May 3, 2019

Ref. T0884

Re: Cate Street Extension Roadway Design & West End Yards Site Stormwater Peer Review

PROJ. No.: 20180317.A10
 DATE: 03/18/2019
CS-101

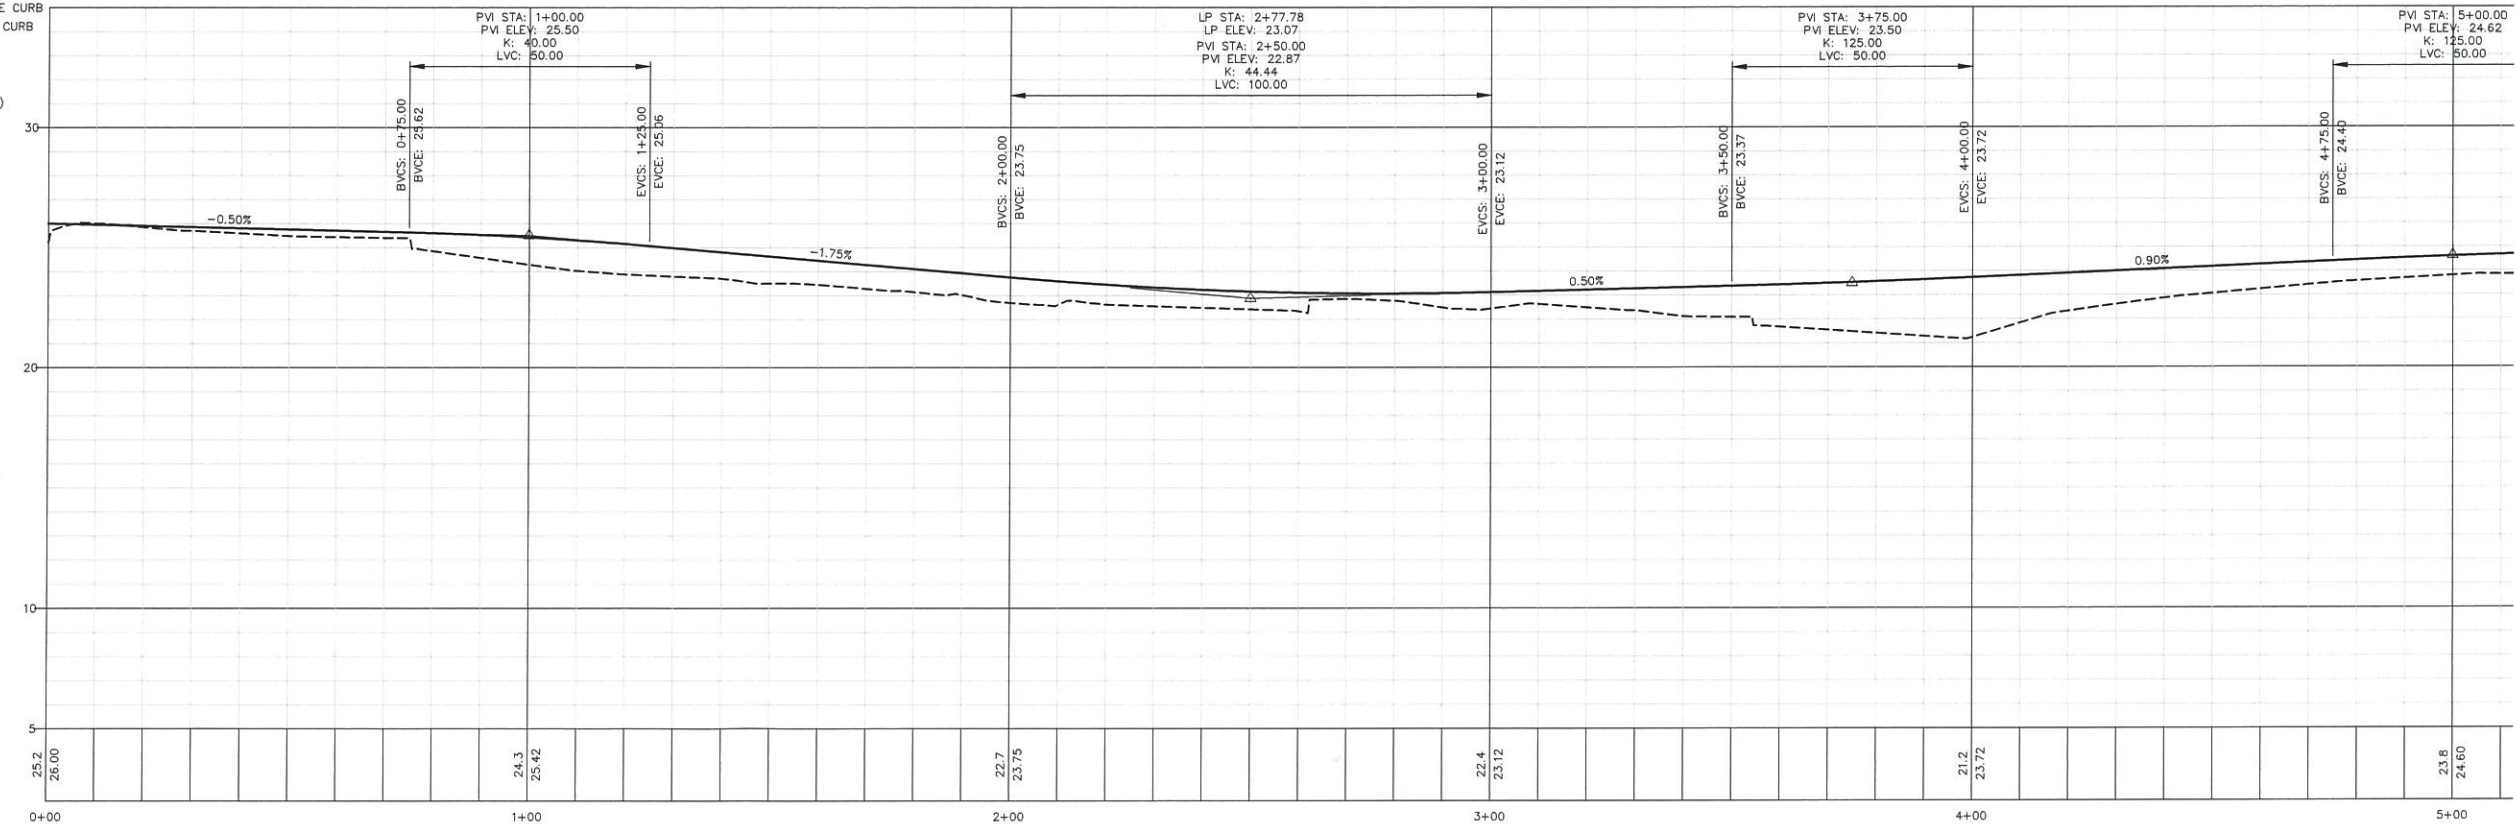
2. The proposed alignment of Cate Street Extension at the Route 1 Bypass / Borthwick Avenue intersection causes the westbound through movement to approach the existing raised median island within Borthwick Avenue at an angle. Consider revising the alignment of Cate Street Extension at this intersection to provide a better alignment for through traffic (refer to attached markup of Sheet CS-101).

3. Consider revising the proposed 20-foot radius at the northeast corner of the Cate Street Extension / Route 1 Bypass intersection to a 50-foot radius. It is noted that the existing traffic signal mast arm foundation is at the edge of pavement and is a design constraint. However, if the northern curb line of Cate Street Extension were re-aligned and shifted to the south as suggested (refer to attached markup of Sheet CS-101), a 50-foot radius curve may fit while maintaining the existing traffic signal mast arm and guardrail.

4. The Cate Street Extension westbound approach to US Route 1 Bypass appears to be excessively wide. Consider revising the approach layout (refer to attached markup of Sheet CS-101).

8. Consider extending the raised median island on Cate Street Extension from Station 1+60 to Station 3+50 (refer to attached markup of Sheet CS-101). While this would restrict the U-Haul driveway access to right-in / right-out only, allowing left turns at this intersection may be a safety concern given, its proximity to the signalized US Route 1 Bypass intersection. It is understood that U-Haul may have requested full access to this intersection; however, further coordination should be conducted to ensure the long-term operational safety at this driveway access.

9. Remove the horizontal angle point in the proposed alignment at Station 4+50.47 (Sheet CS-101). Utilize a horizontal curve at this location with radius and length appropriate for the intended design speed of the roadway.
